Subject: Smugglers Notch Inquiry

Lifside Ski Lockers

Existing Lockers

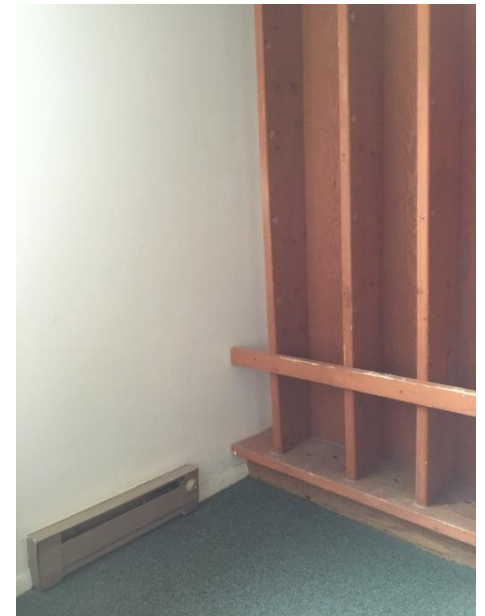
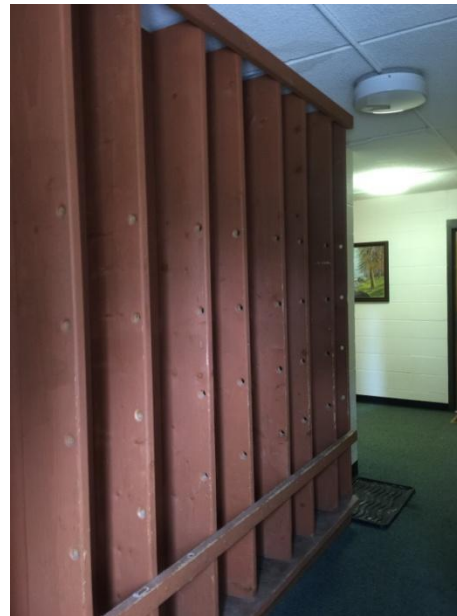
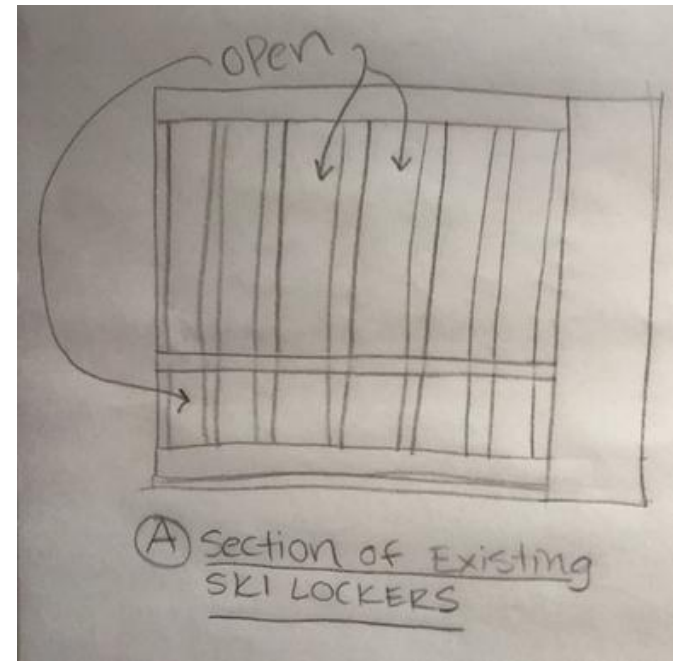
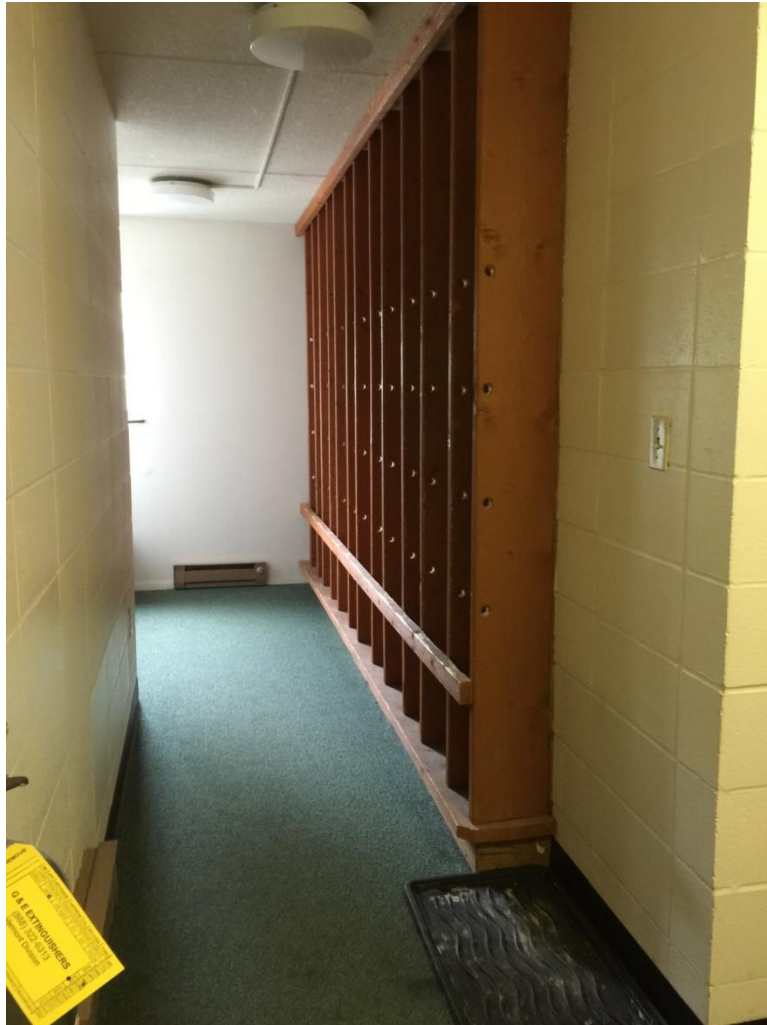
Sprinklers. There are currently NO sprinklers in the buildings common area, where the ski lockers are currently located. The design that we have proposed, takes the fully open ski lockers and adds a door in order to lock them. The door would not be a full door, however there is still some concern. Could you clarify whether or not we would be required to install sprinklers for this change? I've attached some simple hand sketches to better explain the situation. Please don't hesitate to call me with any additional questions.

This installation of partially enclosed ski racks in the halls will not require the installation of sprinklers.

Proposed Lockers

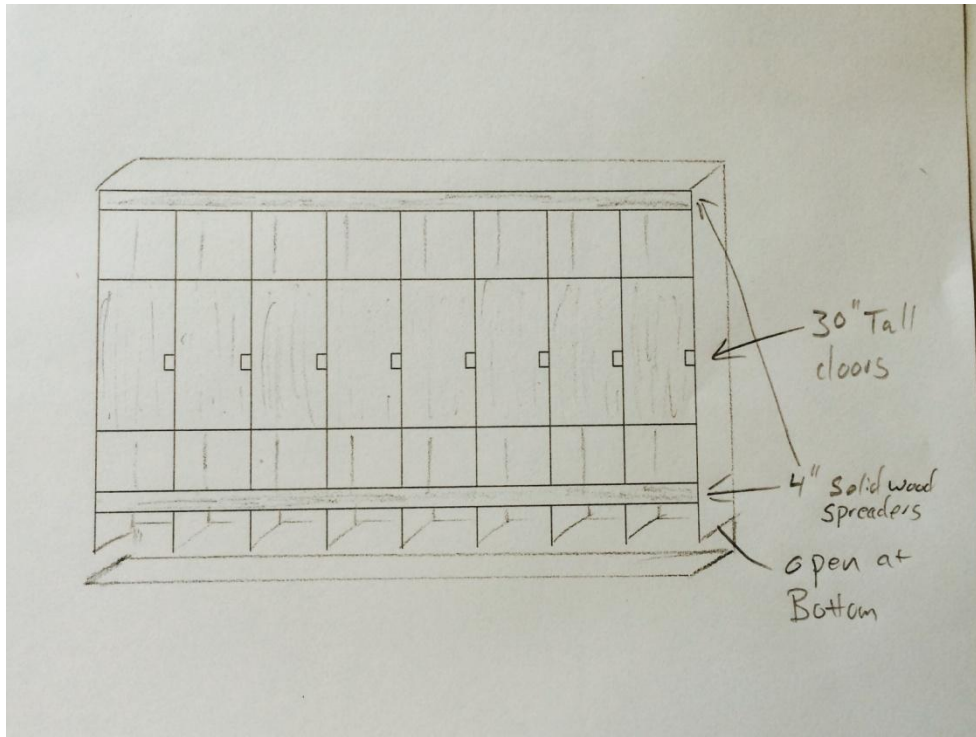
Are these lockers only for skis?
